Subject: AP1000 Response to Request for Additional Information (SRP 23)

Response to Request for Additional Information on SRP Section 23

RAI Response Number: RAI-DCP-CN66-SRSB-01
Revision: 0

Correction to Section H of Figure 6.3-2

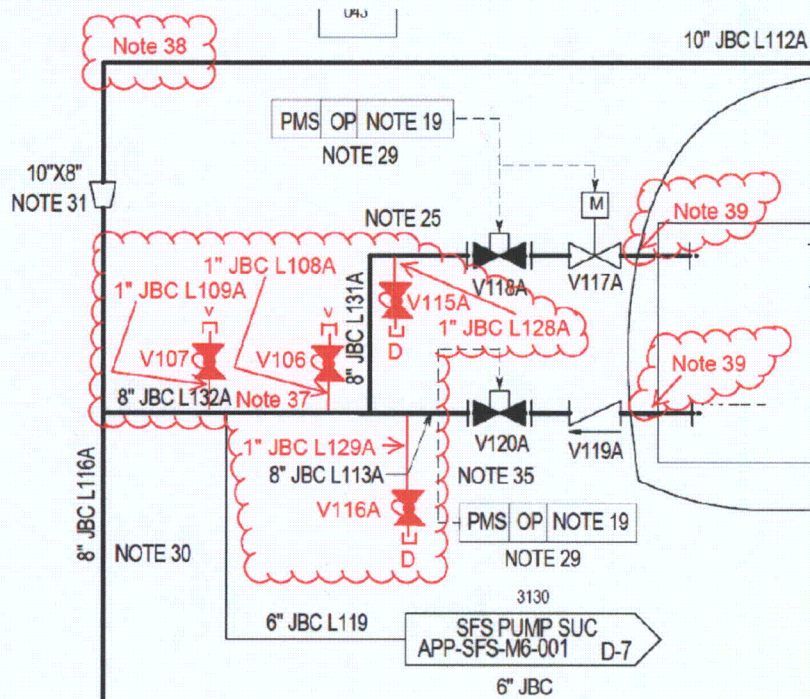
In its May 25, 2010, letter, Westinghouse proposed system specific changes to address gas intrusion. These changes included adding containment recirculation (CR) highpoint vent valves. In DCD Tier 2, Table 3.2-3, the CR train A highpoint vent valves are identified as PXS-PL-V106 and PXS-PL-V107; however, on Figure 6.3-2 (Section H), the CR highpoint vent valves are identified as V106A and V107A. It appears that there are no CR highpoint vent valves identified on CR train B. In addition, Note 7 was included on Section H but not on Figure 6.3-2 Revision 17.

- A. Provide the correct vent valves designation.
- B. Provide an explanation for excluding containment recirculation highpoint vent valves on Train B.
- C. Note 7 does not appear to be included in the provided DCD mark-up. Confirm whether Note 7 will be included in Revision 18.

In its May 25, 2010 letter, Westinghouse proposed design changes included components identified in DCD tables and figures. However, some revision markups do not appear to be consistent between the tables and diagrams. Section H of Figure 6.3-2 identifies valves V106A and V107A enclosed in a revision "cloud" but the same valves in DCD Tier 2 Table 3.2-3 are not enclosed in a revision "cloud." Discuss this apparent discrepancy. In addition, explain why some changes are annotated by red text while others appear with a revision "cloud."

- A. The vent valves should be designated PXS-PL-V106 and PXS-PL-V107 as shown in Table 3.2-3. Section H of Figure 6.3-2 is incorrect and the corresponding valve numbers have already been corrected on the P&IDs in Figure 6.3-2 Rev. 18.

- B. Train A and Train B of the containment recirculation paths are routed differently. Train A was routed with two high points to avoid other components and lines while Train B did not have layout constraints that required somewhat more complicated routing to avoid interference with other components or lines. Therefore, Train B does not have any local high points that could potentially accumulate gas.

- C. The depiction of Note 7 was not supposed to be part of Figure 6.3-2 in DCD Rev. 17 as shown by the absence of Note 7 in the notes section of the figure. The depiction of Note 7 on the figure was not removed coincident with the remainder of the note as it should have been. The markups provided as part of CN66 show this inconsistency with the correct depiction of the note. This issue will be addressed in DCD Rev. 18.
